**PARK CITY REGULAR PLANNING COMMISSION MEETING
SUMMIT COUNTY, UTAH
September 8, 2021**

Sommet Blanc (B2 East) - CUP & MPD Amendment
Exhibit A - Proposed Massing Changes in Context
September 8th, 2021

Sommet Blanc (B2 East) - CUP & MPD Amendment
Exhibit 5 - Hill Glazier Challenges
September 2nd, 2021

Exhibit C - Massing Changes

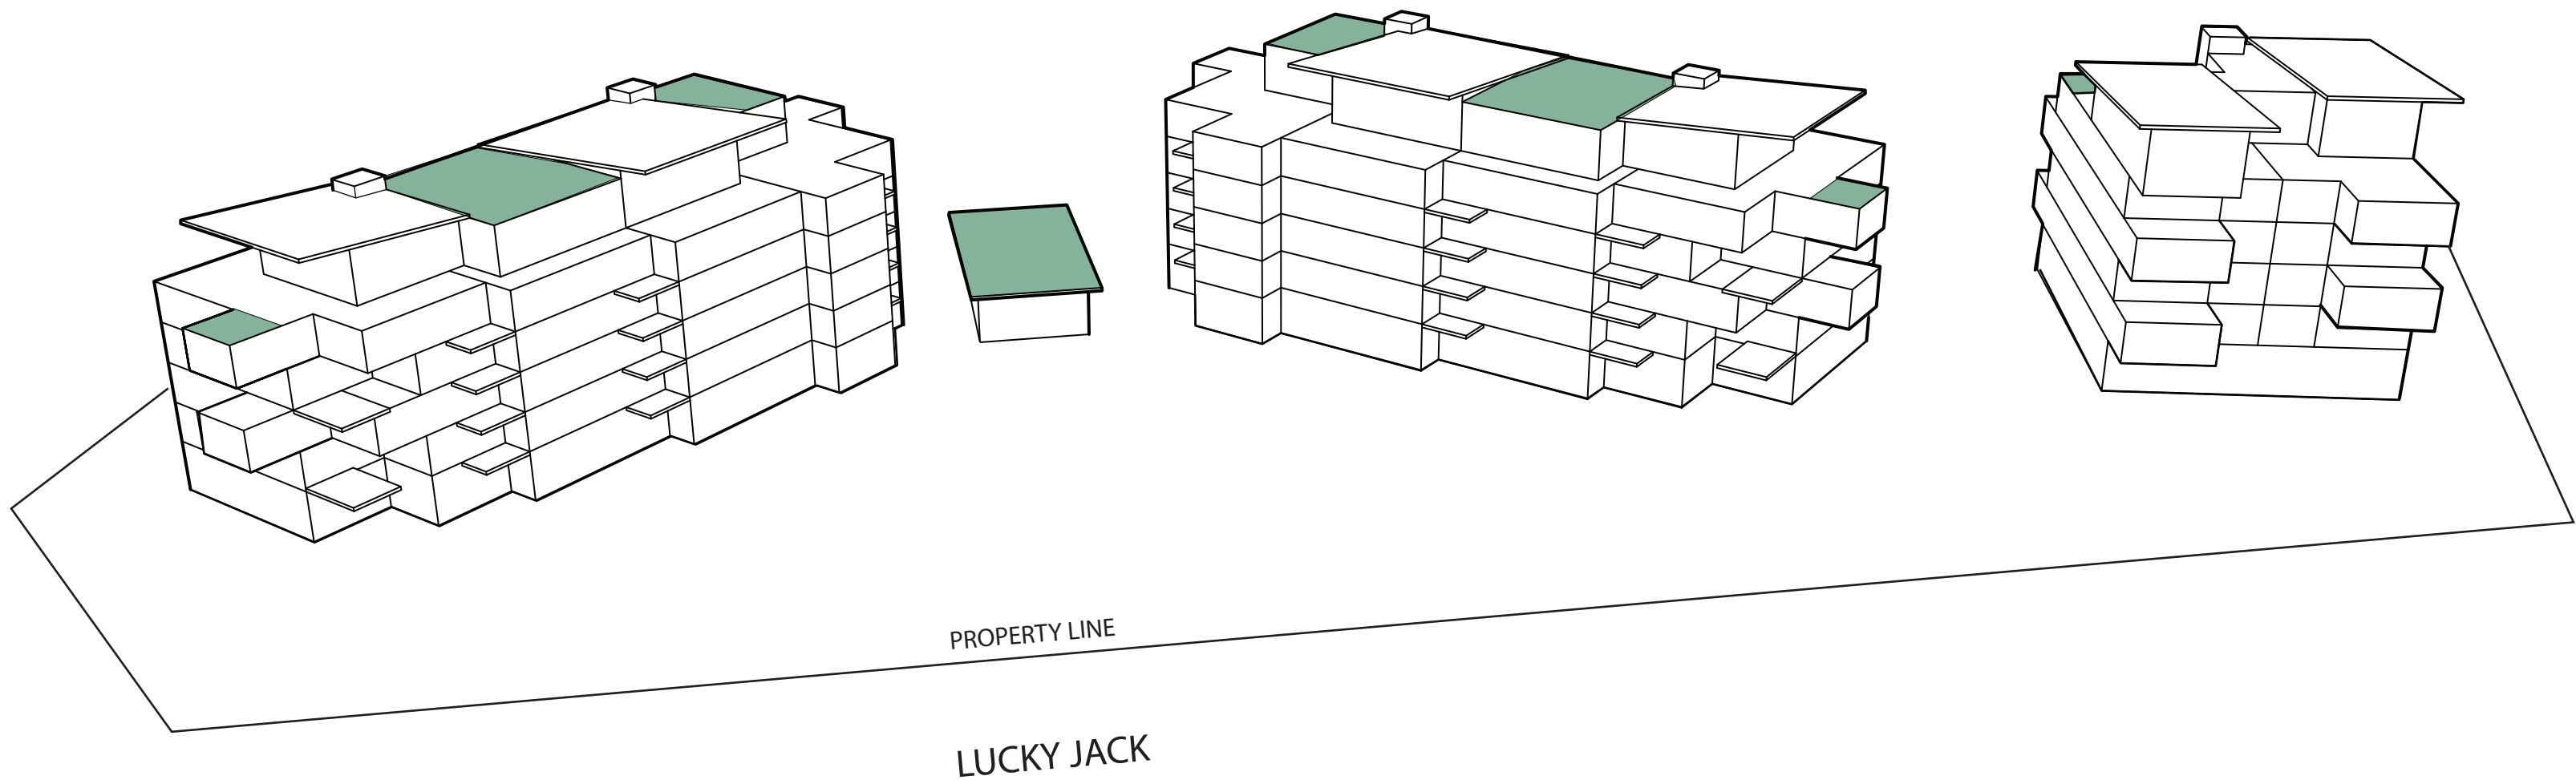
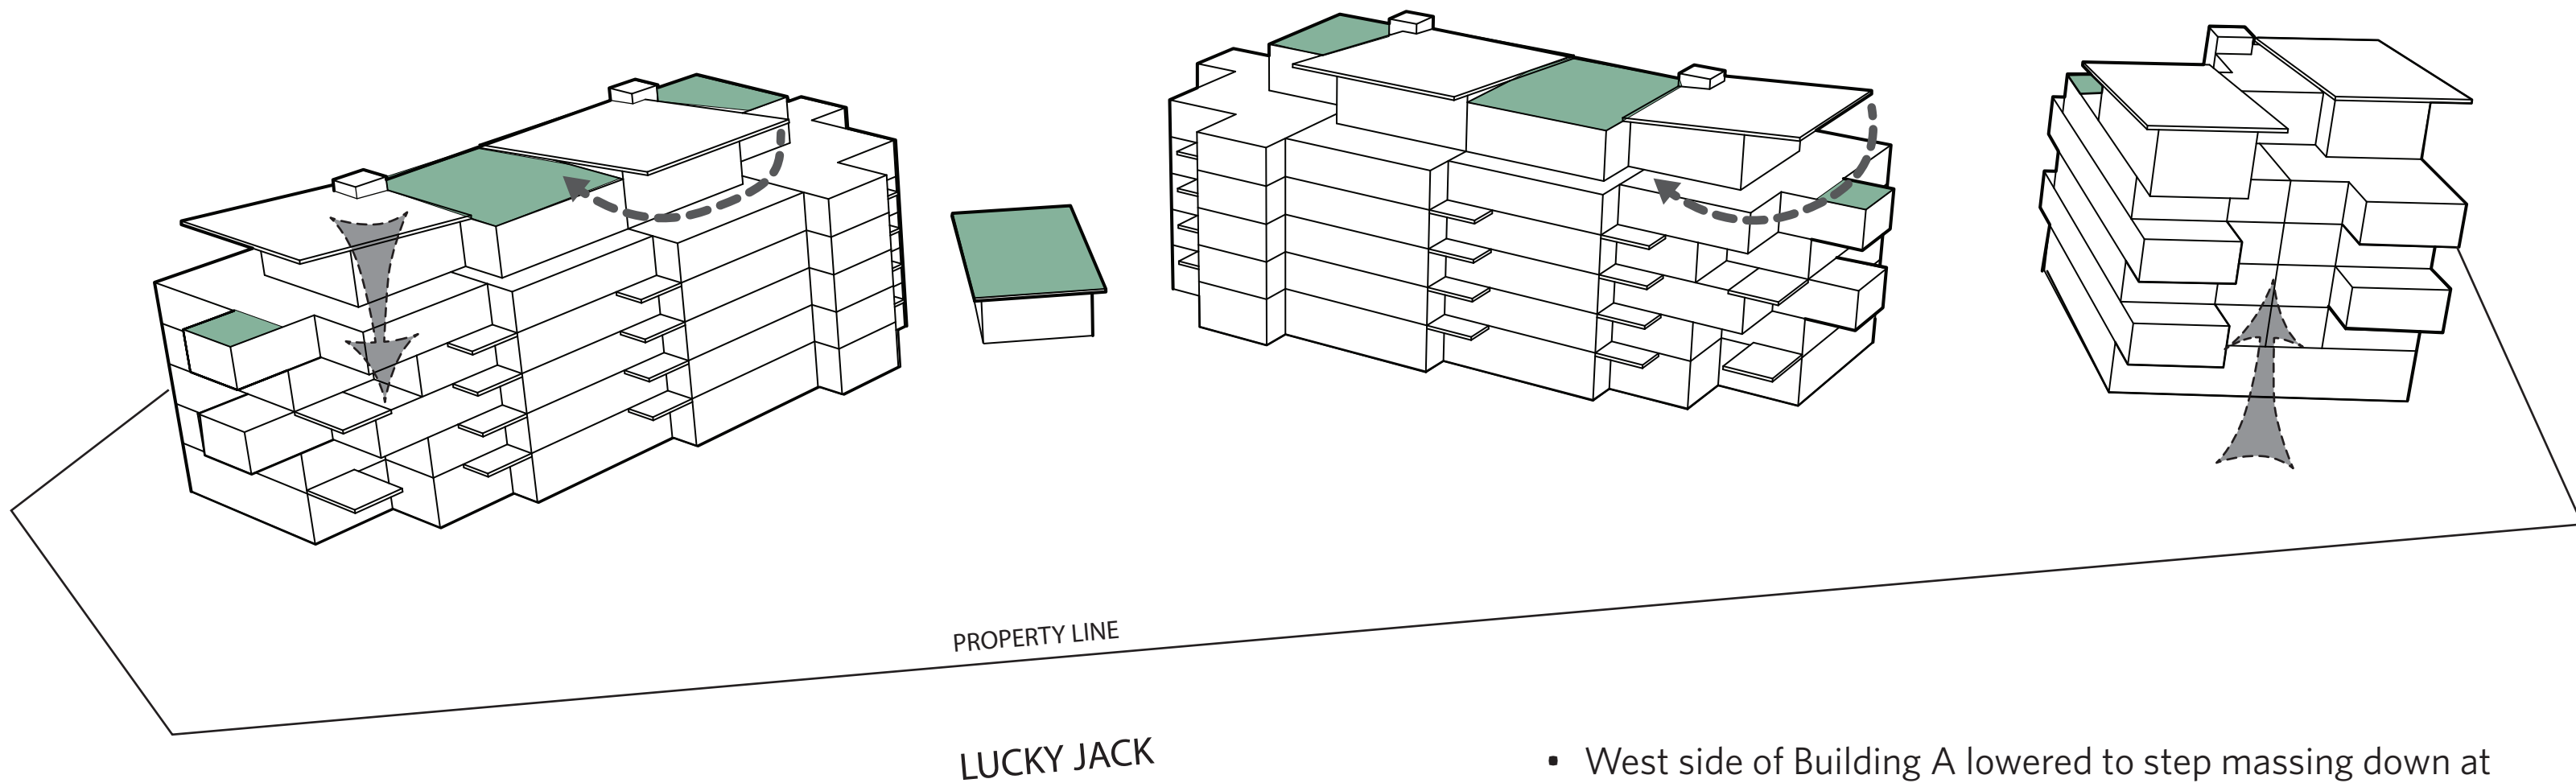
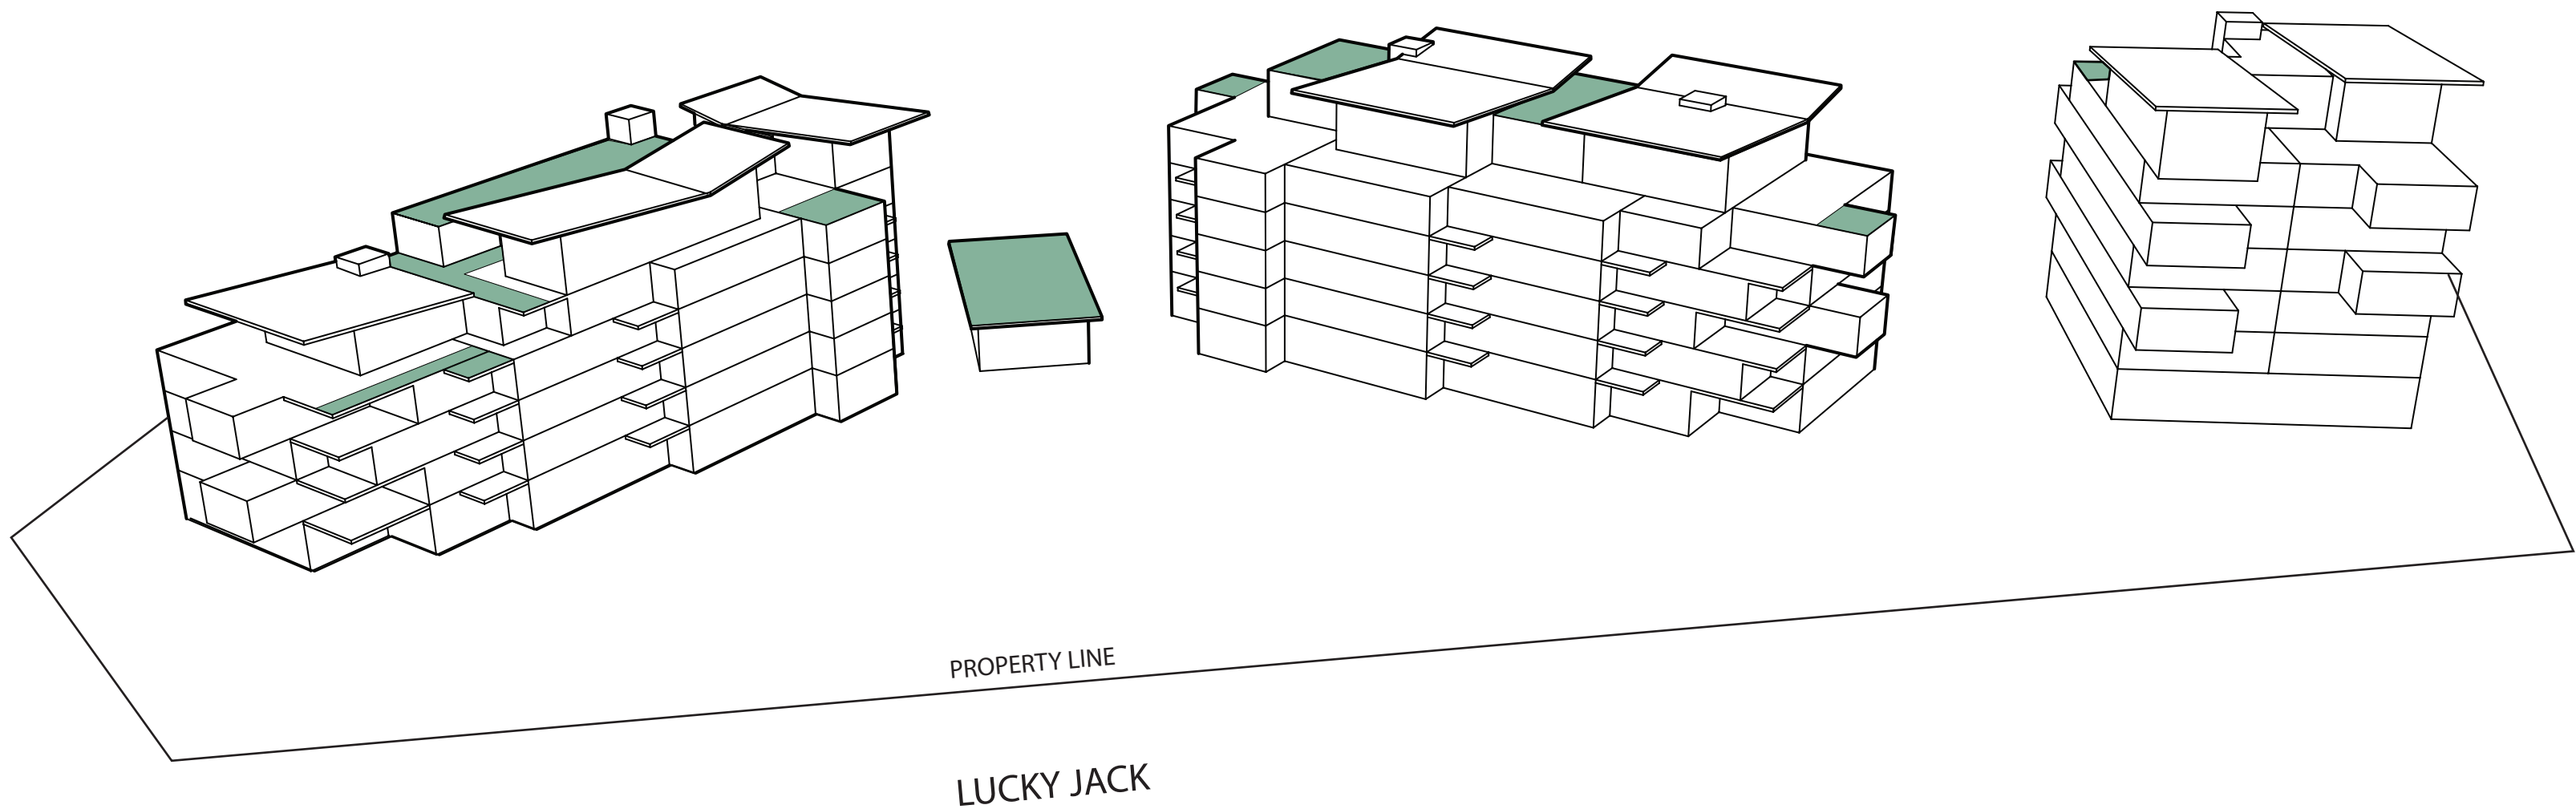
- West side of Building A lowered to step massing down at Empire Day Lodge
- Density shifted from Building A and Villas to Building C
- Building C is one story taller
- Penthouses rotate and adjust to new massing and articulate roofline at both Lucky Jack and Marsac Ave

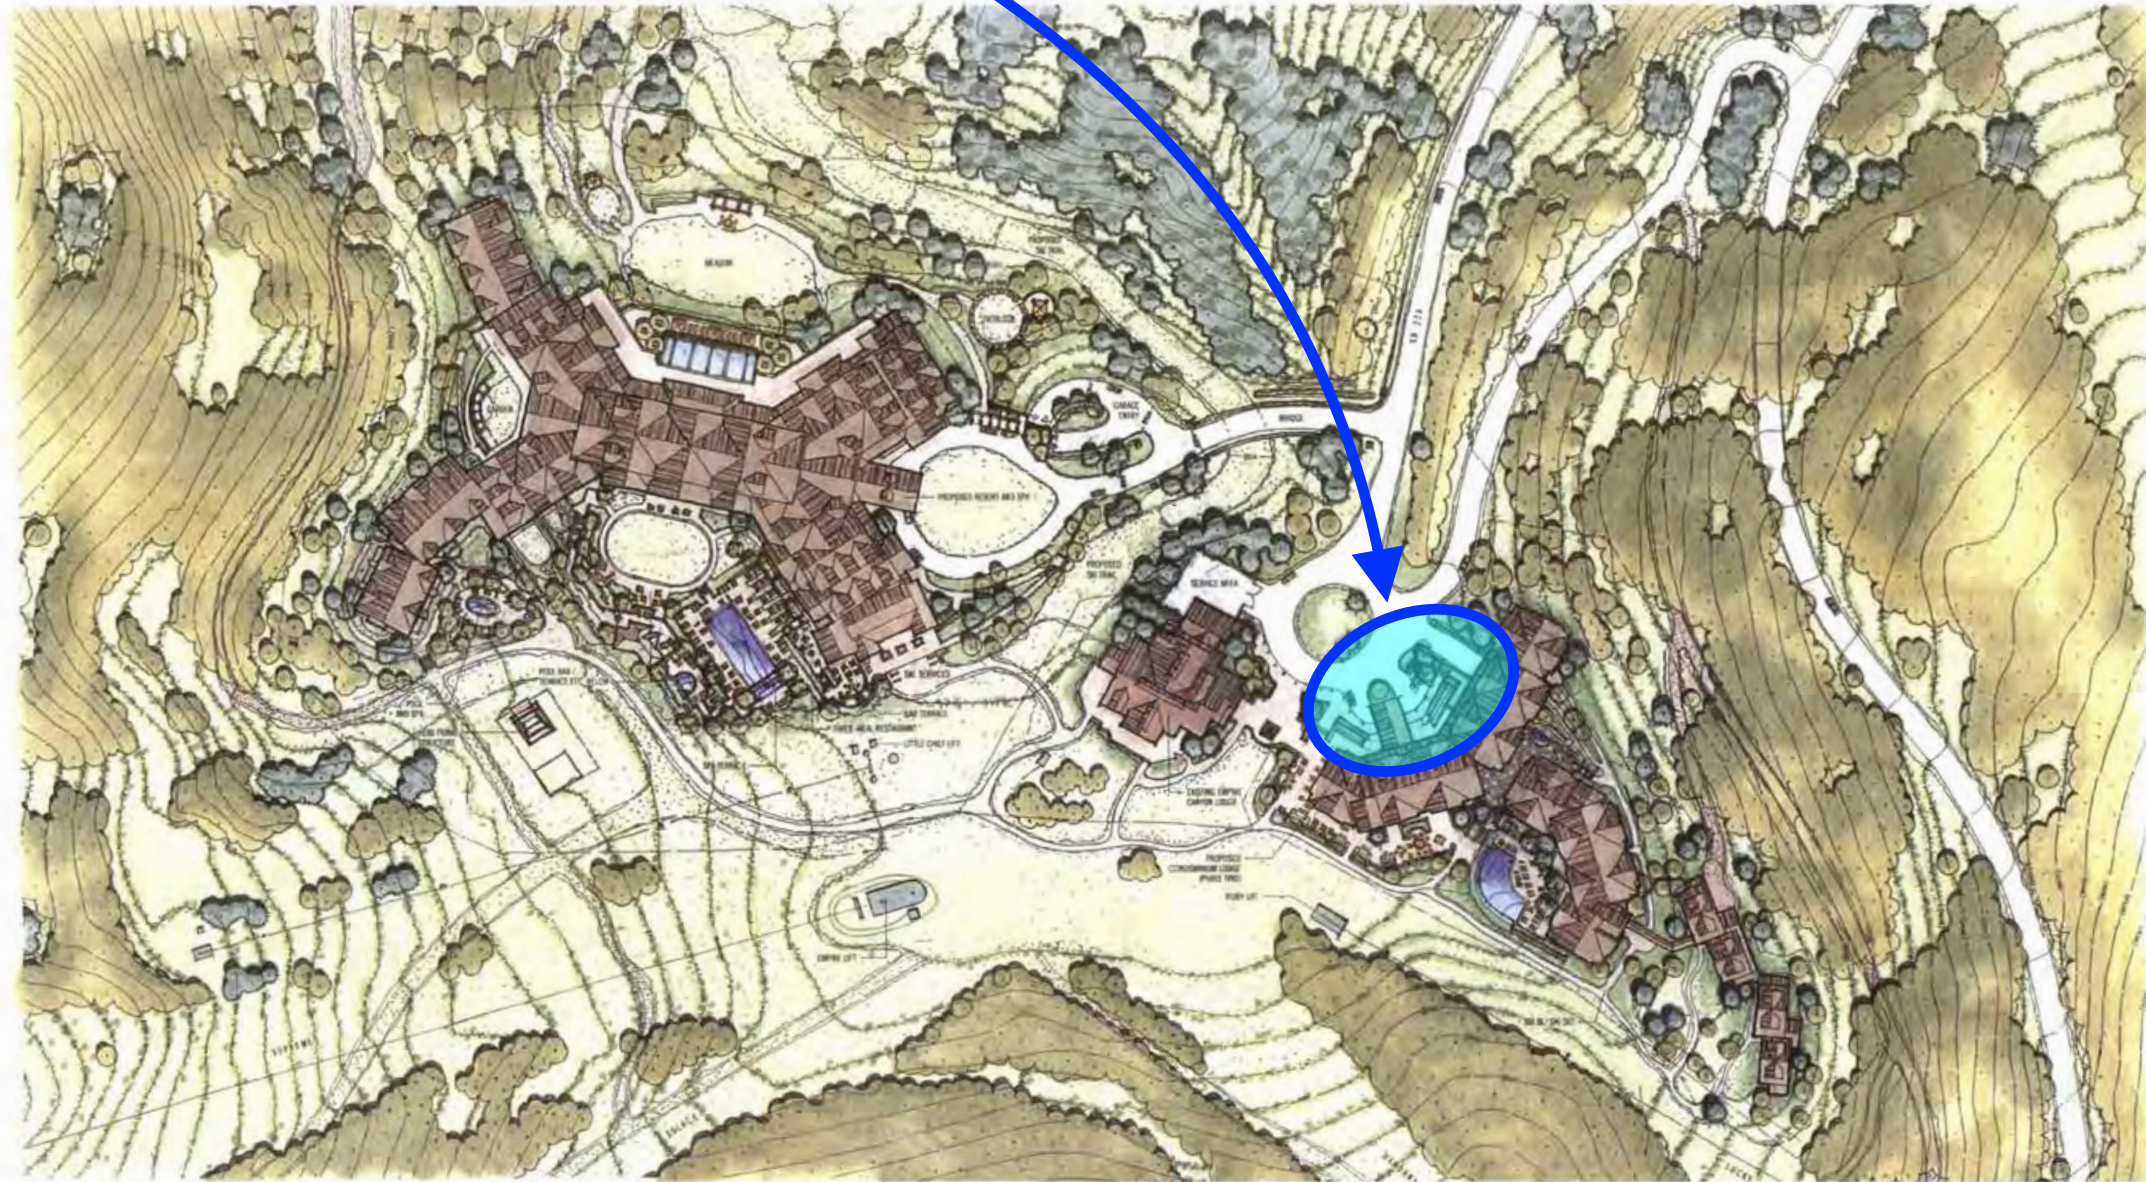
Three B2 East
curb cuts on
Marsac
roundabout

(A) HILL GLAZIER -SECTION A

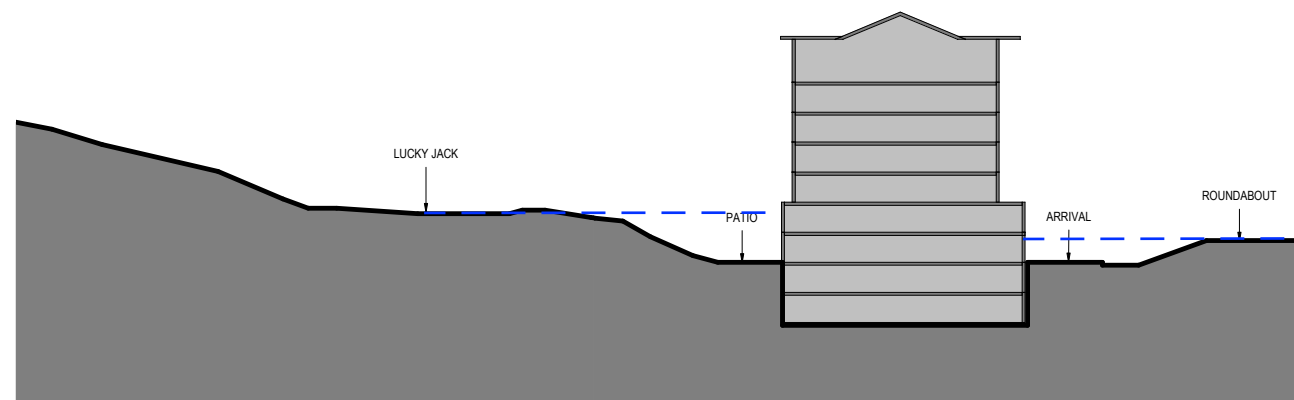
**Patio well below
Lucky Jack**

(B) HILL GLAZIER -SECTION B

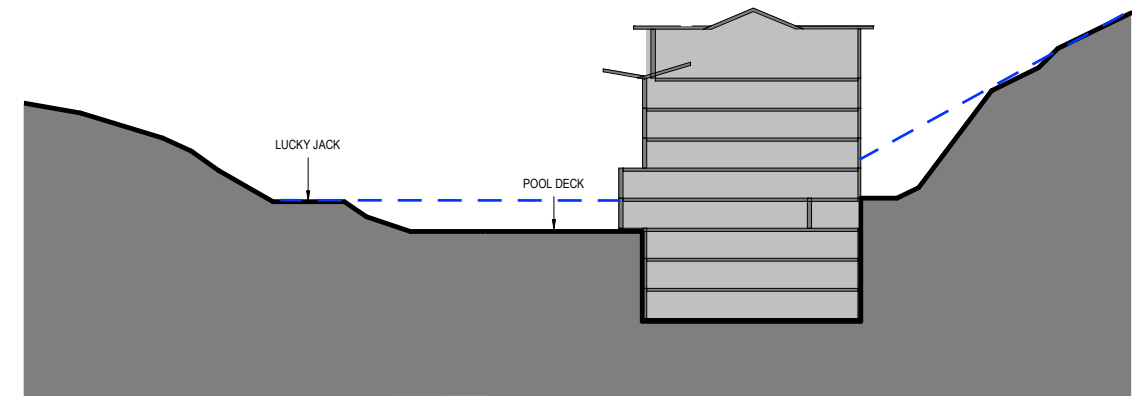
**Arrival below
roundabout**

**Pool deck well
below Lucky Jack**

(C) HILL GLAZIER -SECTION C

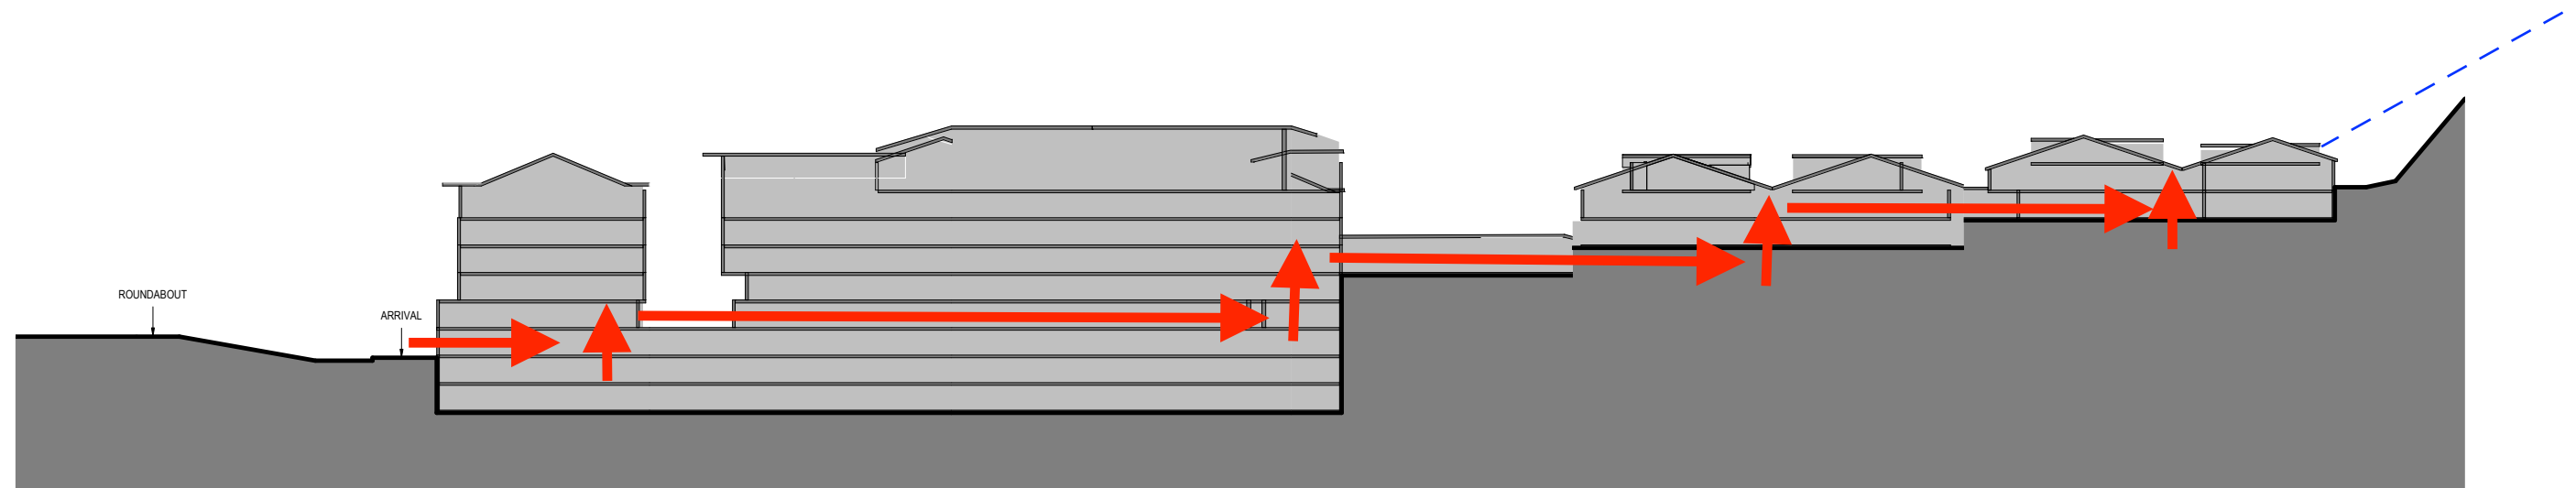
**Massive cut slope
at rear of building**

**Arrival below
roundabout**

**Crazy internal circulation.
See red arrows**
